Product / Process Change Notification (PCN) Major change		
Minor change		
PCN #:	PCN_IndTIS_20201107	Change Category:
Affected Series:	WE-TIS 744731xxx, 7447471xxx	 Equipment / Location General Data Material
PCN Date:	August 07, 2020

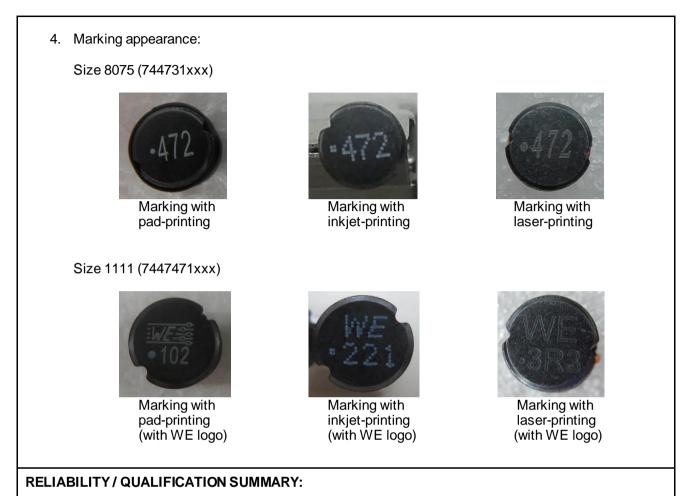
1. All electrical and mechanical properties of the parts will remain the same.		
2. Pad-, inkjet- and laser-printing will be used from now on.		
3. Printing method can be identified on the label by the 13 th digit in the lot number.		
LotNo. for pad-printing: xxxxxxxxxx0xx		
LotNo. for	inkjet-printing: xxxxxxxxxxx1xx	
LotNo. for	laser-printing: xxxxxxxxxxxx2xx	
(1P) Part No.: 744 772 010 (Q) Quantity: 2 800 pcs. (1T) Lot No.: 227260011314000 (1T) Lot No.: 227260011314000 (16D) Date Code: 2015 - 03 - 30 etBos Made in China etBos Made in China EtBos Made in China Label example for pad printing (13 th digit marked in red)
